Re: Abengoa Mojave Solar Project (09-AFC-5): Second Supplemental Written Response to Data Request Set 1B (Nos. 1-86) for Water Resources

Soils and Water Resources (21-61)

Figure 31-3(a). Water-level declines in 2042 for the 'dev1' case (calibrated model with all Abengoa wells pumping). The decline is compared to the calibrated model without the Abengoa wells.

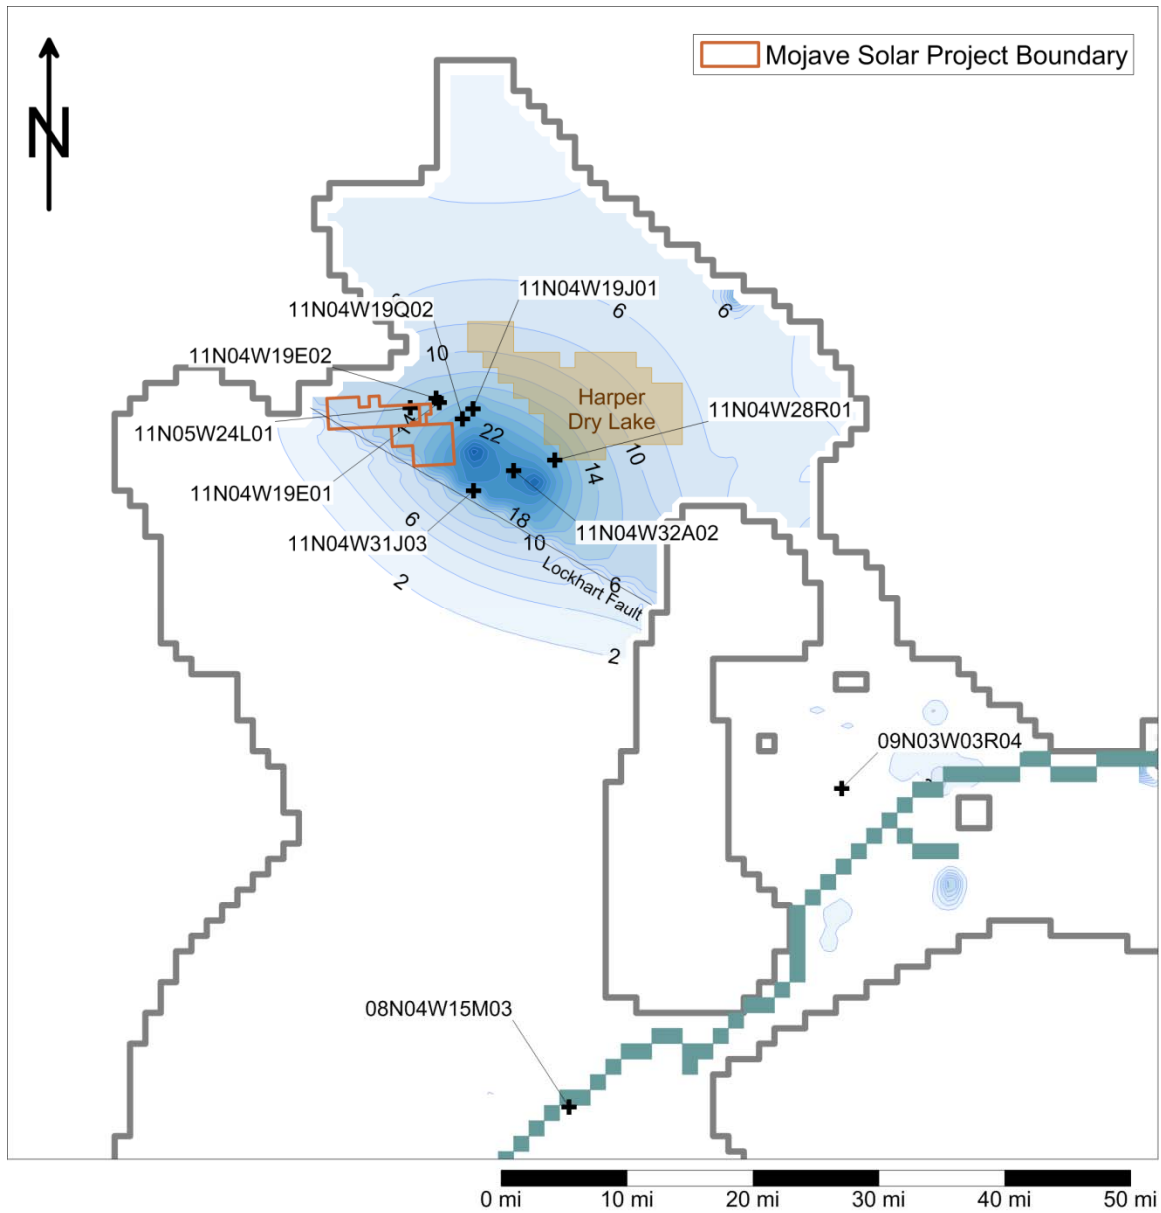
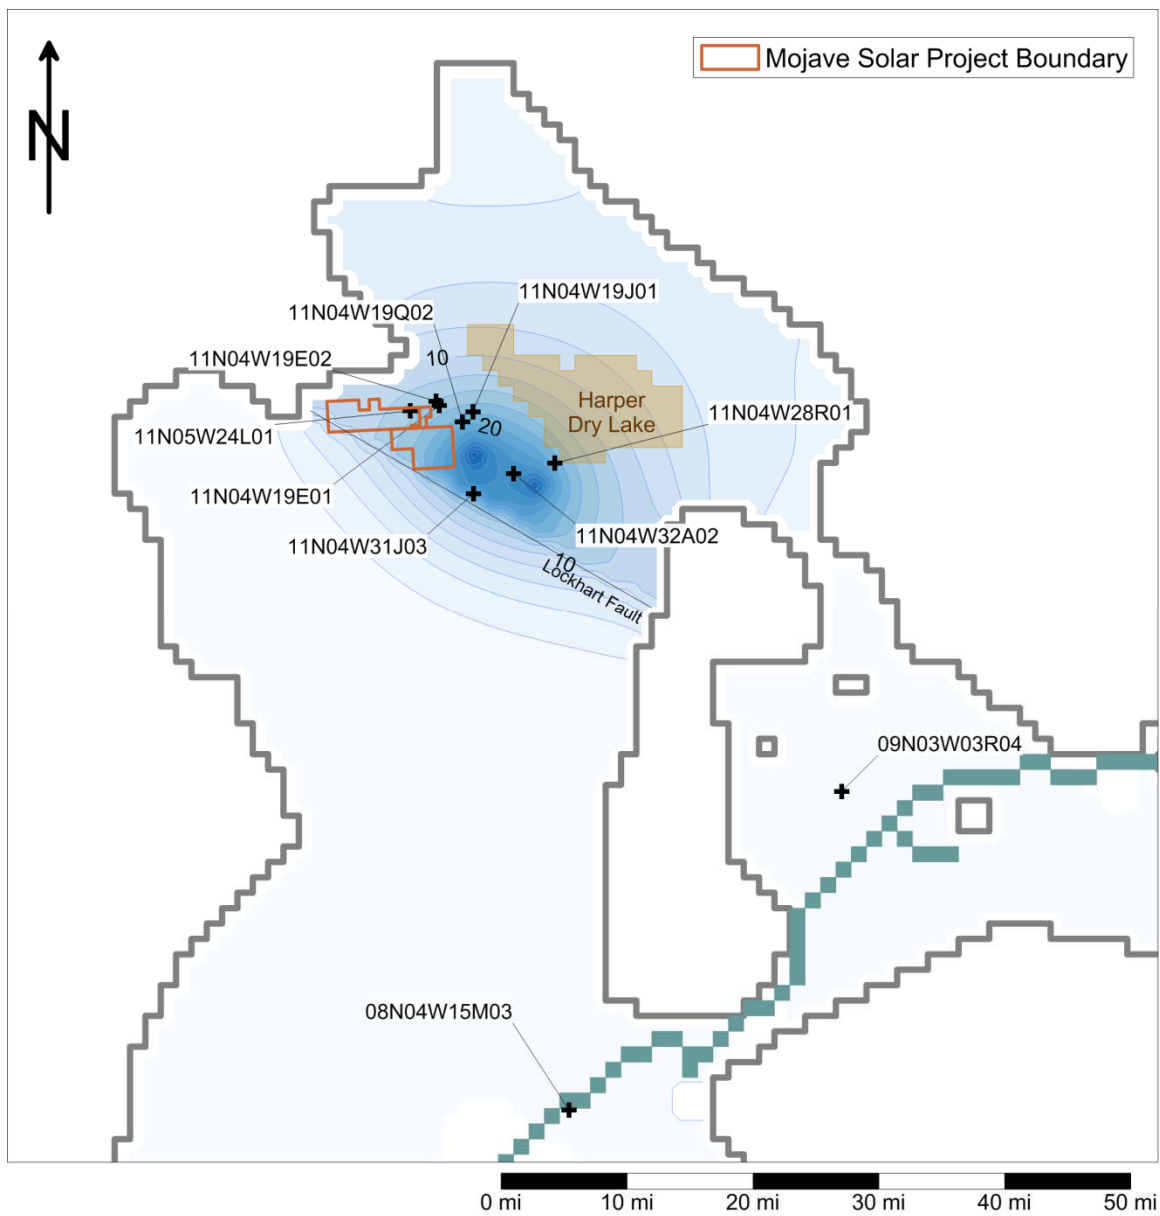
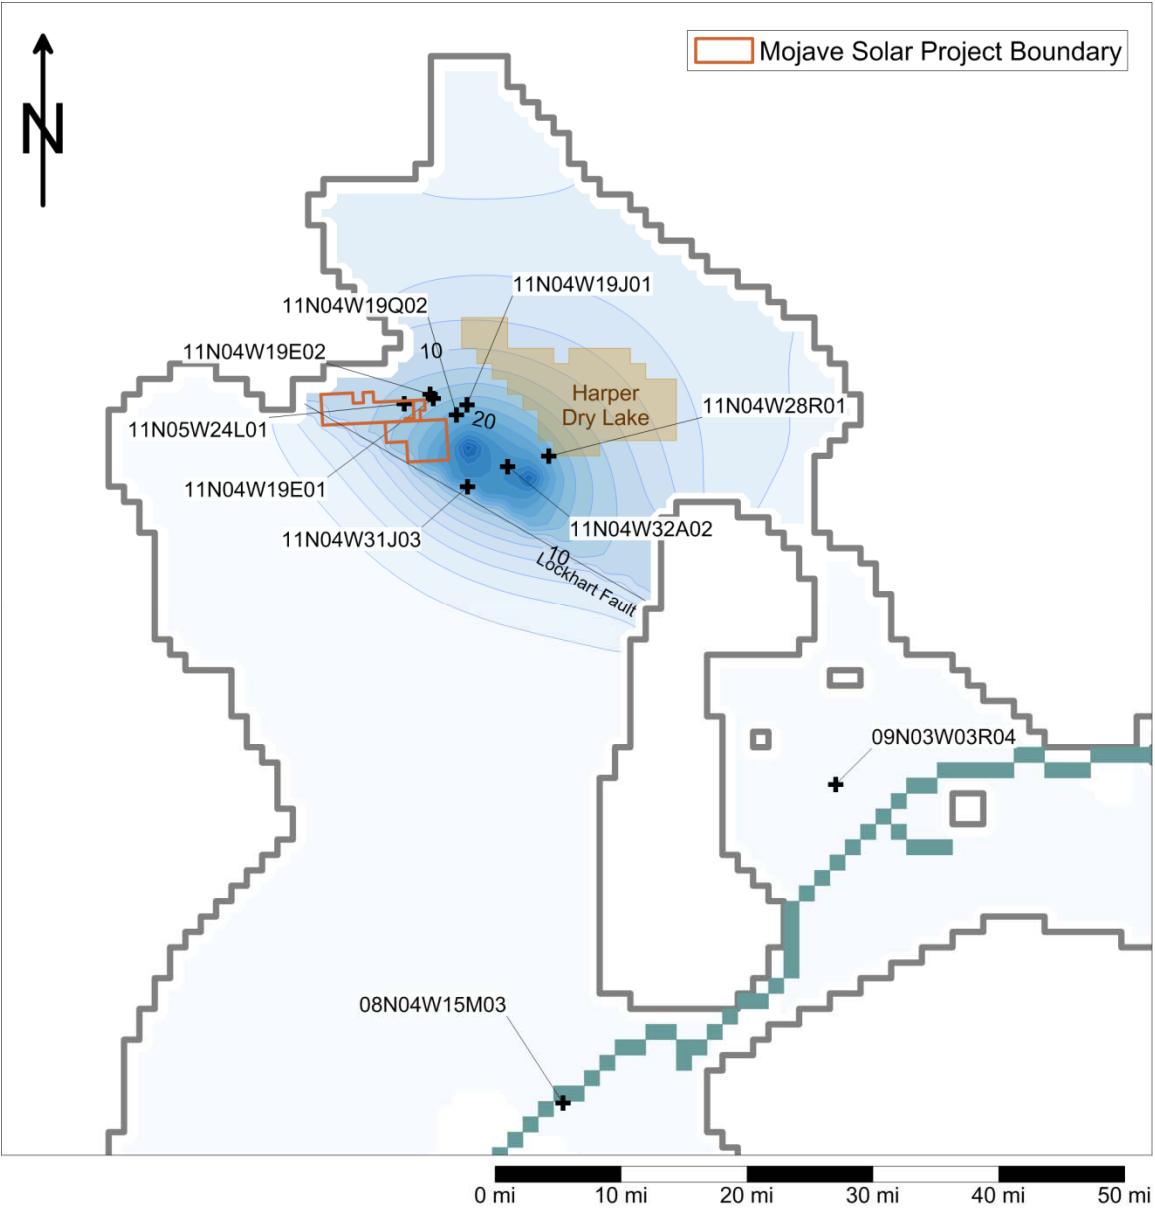
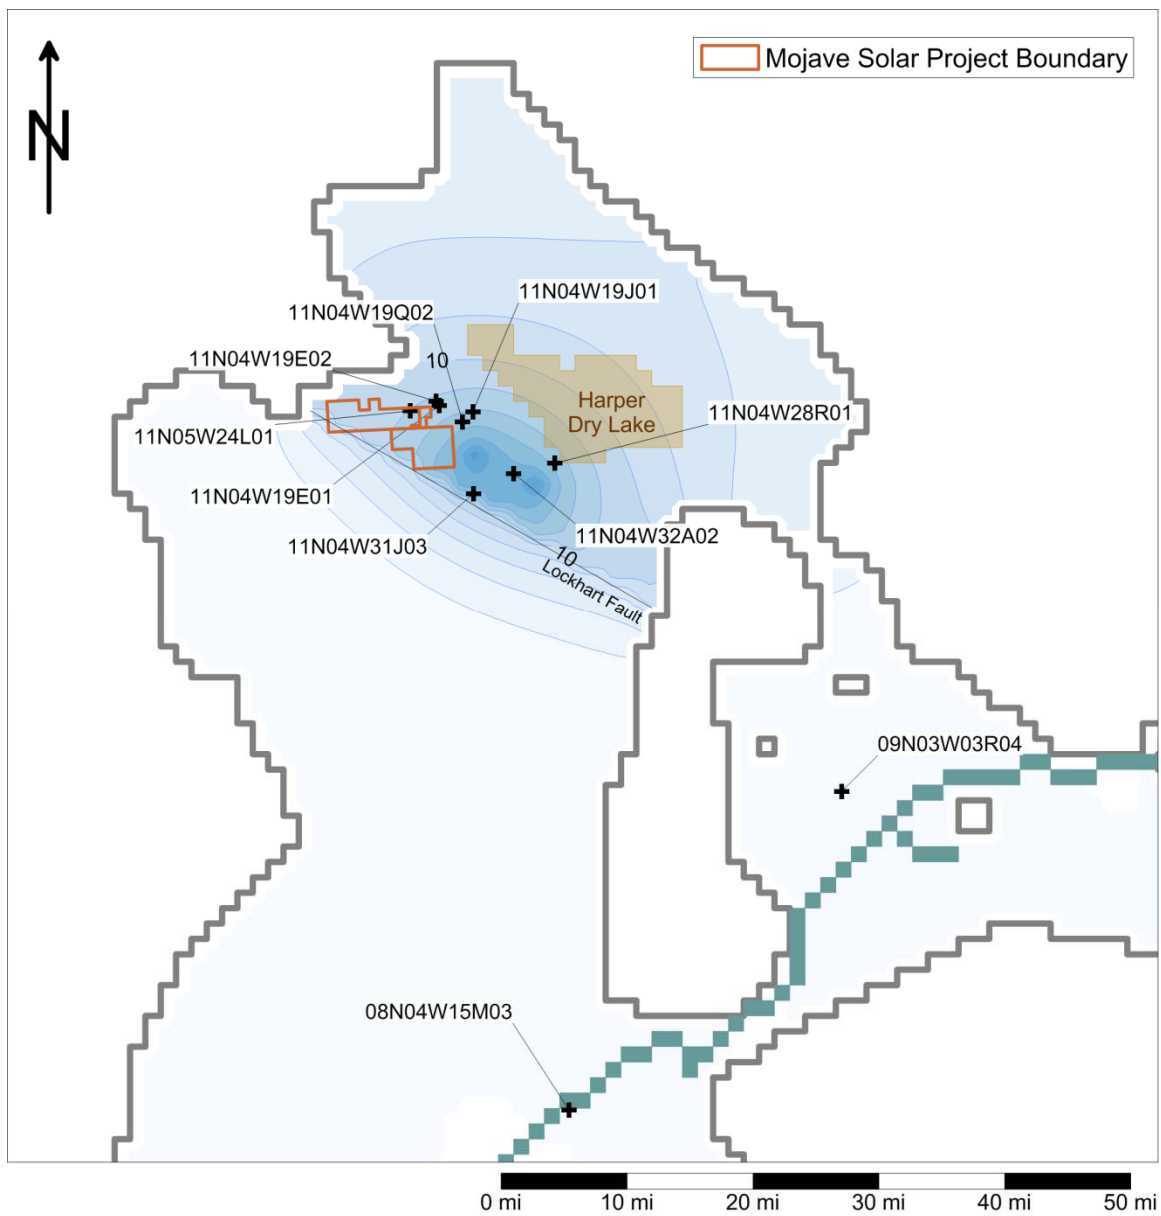
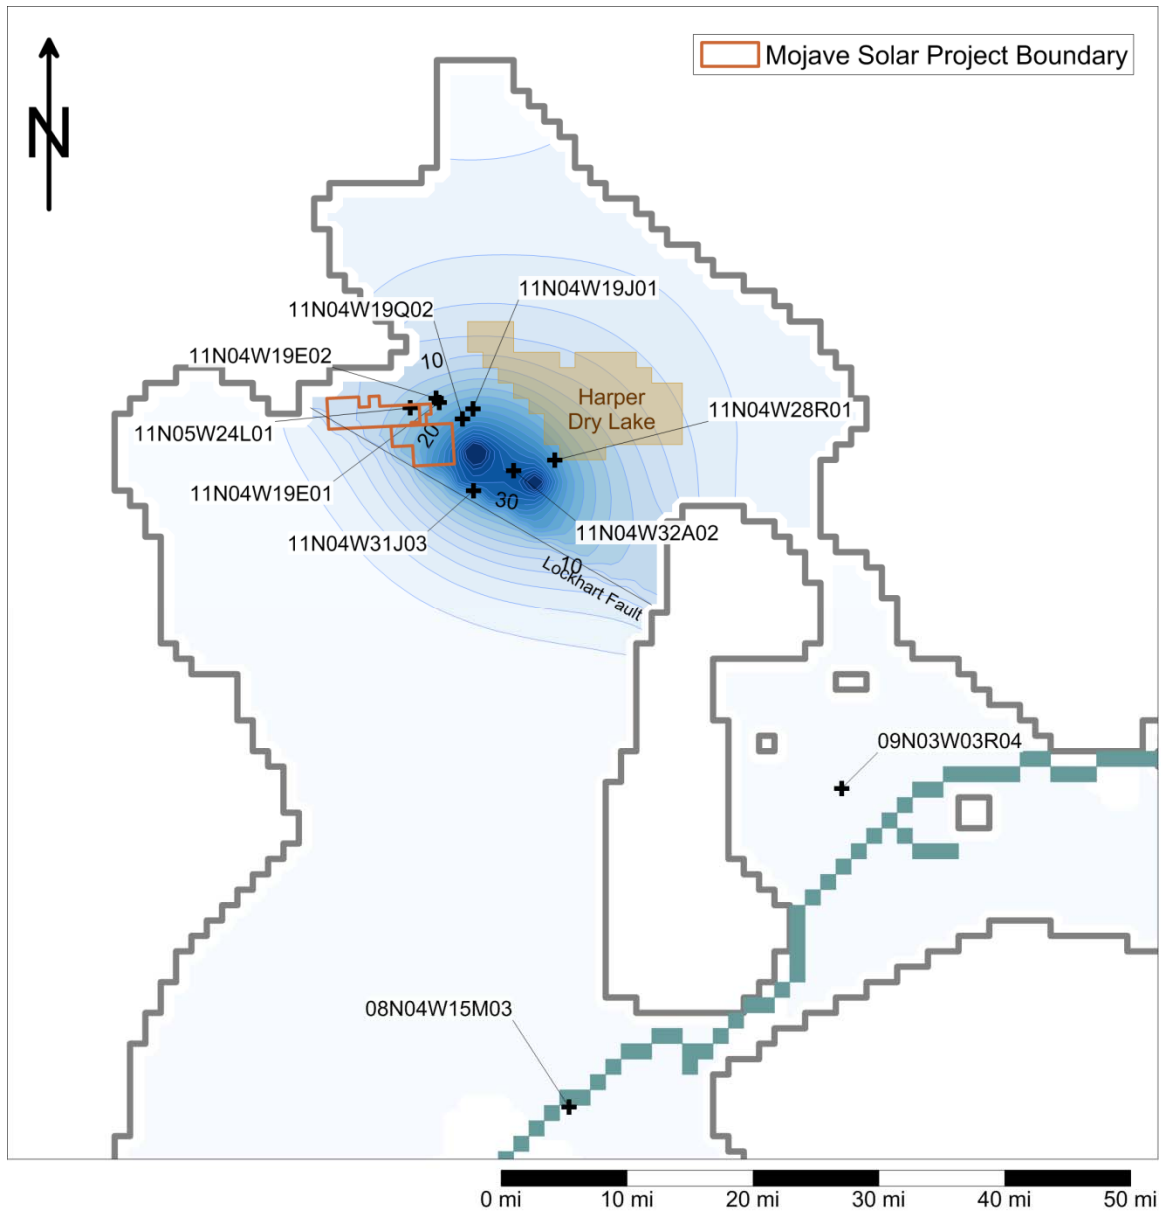
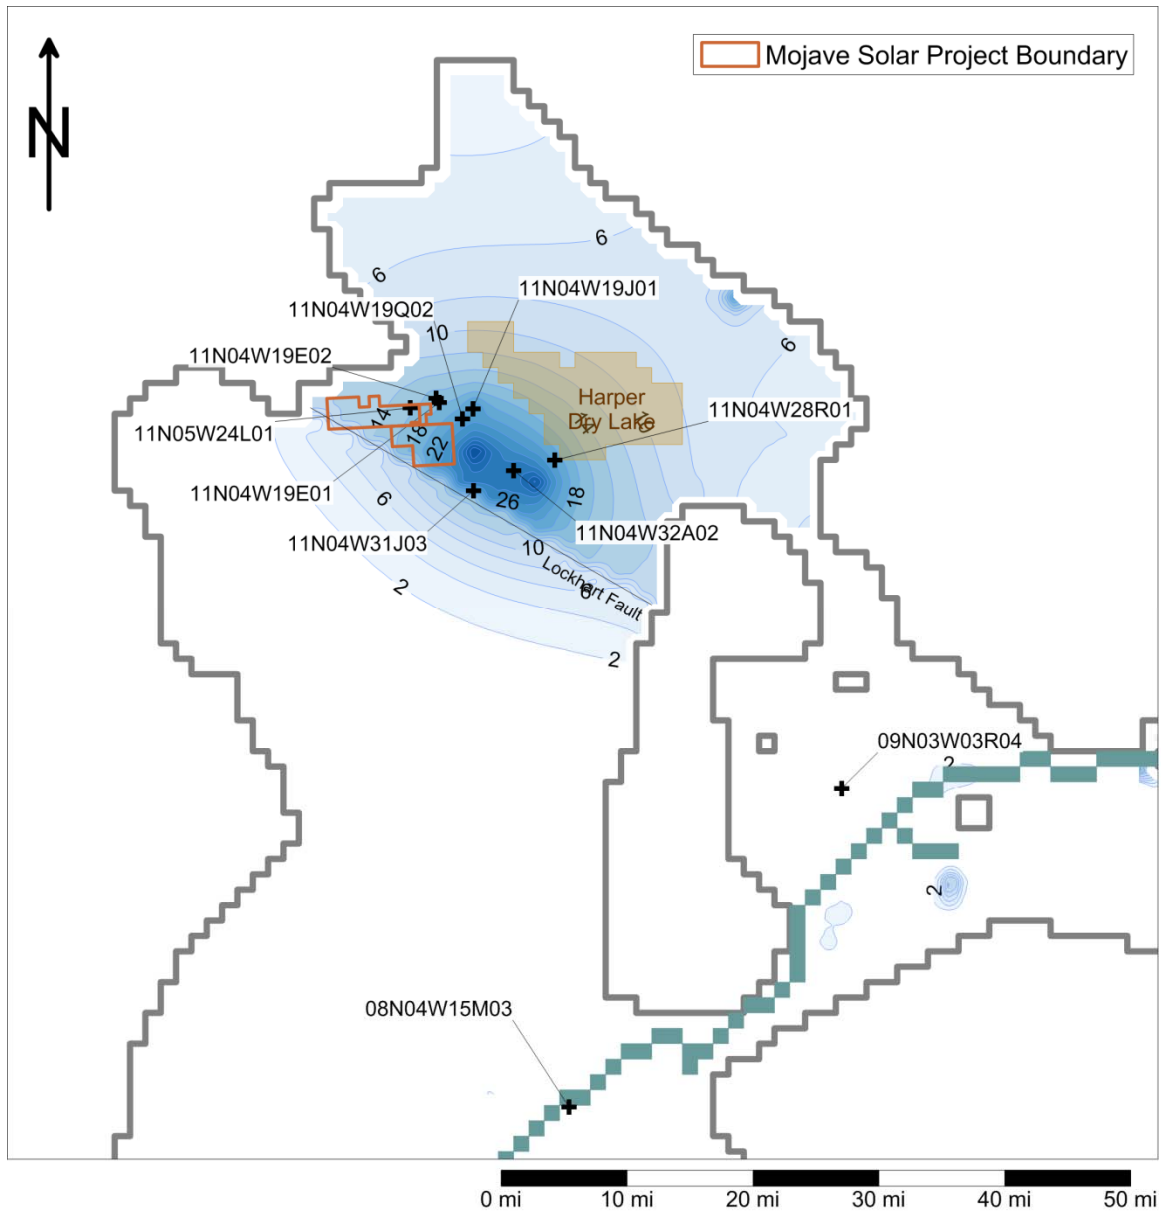
Please provide a table that summarizes the range in simulated impacts at the existing wells tabulated above to represent a plausible range in aquifer property values from previous studies, the literature, and model calibration.

Attached Figures 31-3(a-f) provide simulated water-level declines as compared to the case where the Abengoa wells are not pumped for the six predictive scenarios described previously.

The following Tables 45-1(a-f) provide tabular impact summaries for all wells in the HVGB for each predictive scenario. The impact is presented as the difference in the water level between the predictive scenario and the case where the Abengoa wells are not included (the 'pre' scenario). As shown in the tables, for all scenarios, there are no impacts to any existing wells due to pumping the Abengoa wells. In no instance does the predicted water level in 2042 fall below the benchmark 1995 level. In fact, in most cases the water level is predicted to rise from 1995 levels.
